Poverty Flats Appeal Chapter 7: Hydrology & Water Supply

Section A: Project's Inadequate Groundwater Analysis, Fair Argument – Substantial Evidence of Limited Water Supply in High Valley

Figure 20: Within a one-mile radius, there are zero pending [green dots] and one approved projects (sic) [yellow dots]

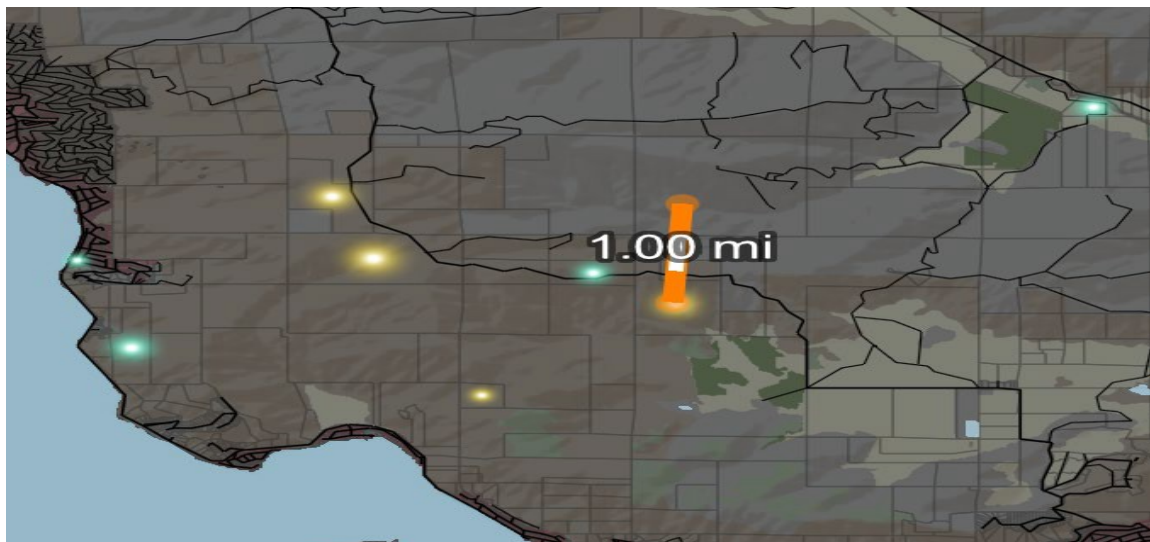
The project’s analysis of cumulative impact on groundwater supply is insufficient. The project’s cumulative analysis on groundwater supply consists of

- **Missing data from tally of area cannabis projects.** The tally does not provide number of wells per project, well depth, well yield, estimated project water usage, evidence of sufficient groundwater supply for the project, and actual water usage (for approved projects). A true understanding of the project’s cumulative impact on groundwater supply is not possible without these data.
